# ADDENDUM No. 1

## RFP No. 973

### Fiber Optic Network Construction Services

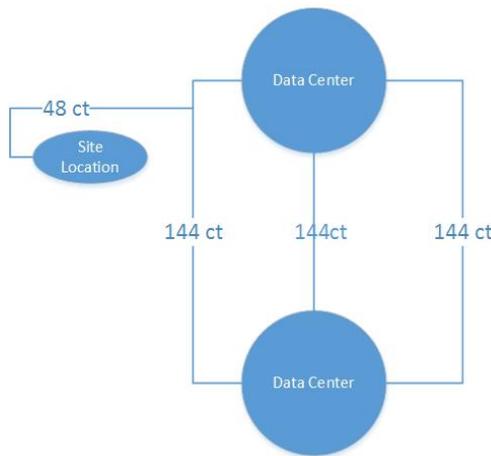
Clarification: **Network Site Locations.** Each site location will be connected by 48-conductor single mode fiber optic cable. 3-pair (6 strands) will be terminated at each site location. The remaining strands will be left un-terminated for future use unless specified otherwise.

The network ring consists of an east and west ring, and a bi-sector, each comprised of 144-conductor single mode fiber optic cable. 144 strands (72-pair) will be terminated at each data center for each ring and for the bi-sector entering each data center. A total of 72-pair for east ring, 72-pair for west ring and 72-pair for the bi-sector will be terminated at the two (2) data centers, patch panel landed and acceptance tested. An illustrative example has been provided below.
